**APPENDIX A**  
**HEARING TRANSCRIPT**

OFFICIAL PLANNING BOARD MINUTES

PUBLIC HEARING HELD BY THE PLANNING BOARD  
OF THE TOWN OF HUNTINGTON, HELD ON THE  
1ST DAY OF OCTOBER, 2008 AT 7:32 P.M.,  
AT TOWN HALL, 100 MAIN STREET, HUNTINGTON,  
NEW YORK, IN THE MATTER OF CANON AMERICAS  
HEADQUARTERS, PURSUANT TO NOTICE OF  
HEARING, AND BEFORE DONNA GILMORE, A  
NOTARY PUBLIC OF THE STATE OF NEW YORK.

Re: Canon Americas Headquarters  
DEIS Traffic Comment Review  
GPI Project No. 2008321.00

*PHOTO 1: Synchro network prepared by the applicant showing additional lane and turn bays (5-lane cross-section) on LIE North Service Road and Old Walt Whitman Road under (2010 Build with DOT improvements)*

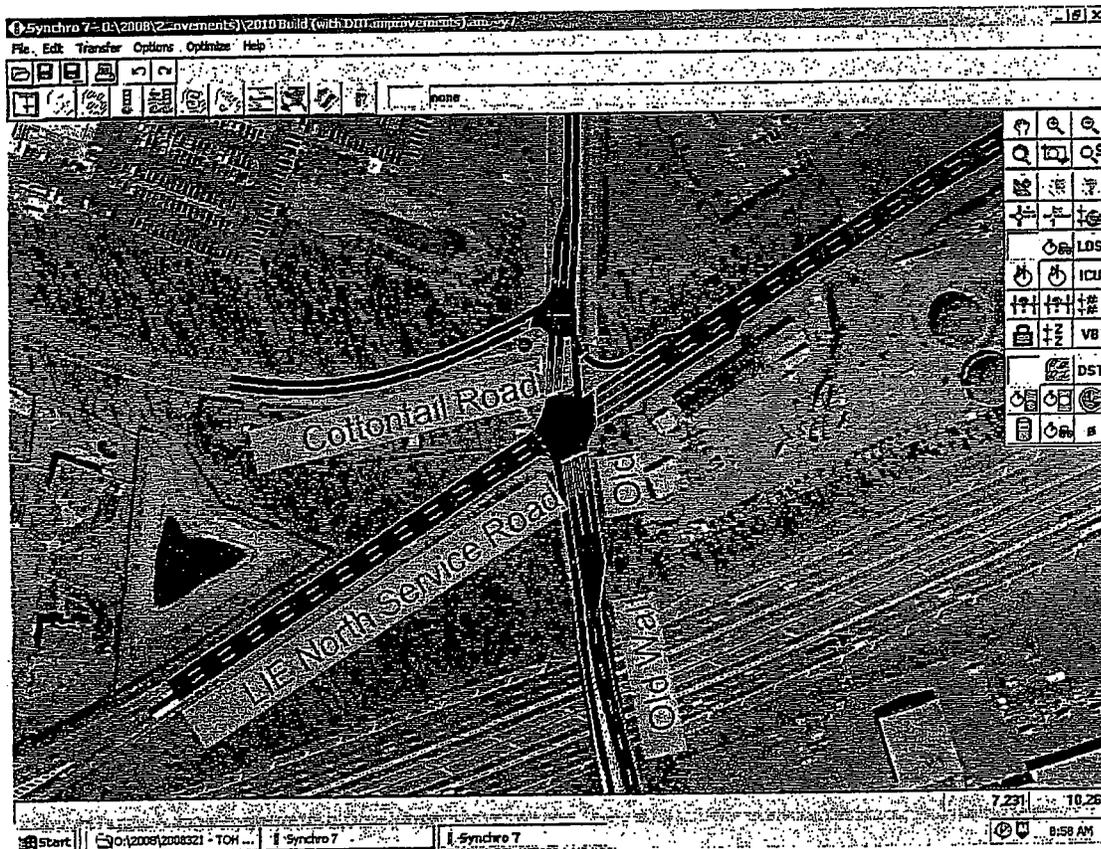
As discussed earlier, under the 2010 Build with DOT improvement analysis at LIE North Service Road and Old Walt Whitman Road has one (1) exclusive left turn lane, three (3) through lanes and one (1) exclusive right turn lane on WB approach. Three through lanes are carried forward to west of Old Walt Whitman Road (see Photo 1). While Town of Huntington improvements show one (1) left and through shared lane, one (1) through lane and one (1) exclusive right turn lane on WB approach and it shows two (2) lanes west of Old Walt Whitman Road. No other improvements are proposed by NYSDOT at this intersection. Thus, the assumed additional lanes and turn bays in the analysis by the applicant are resulting in better traffic operating conditions than anticipated at this intersection. In reality, the results would show different operating conditions that may warrant additional mitigation.

At this time, Canon has not taken responsibility for this mitigation. We would like to know if the applicant is willing to add the lanes/turn bays as suggested in the analysis as it is not proposed either by the Town of Huntington or NYSDOT for their respective projects.
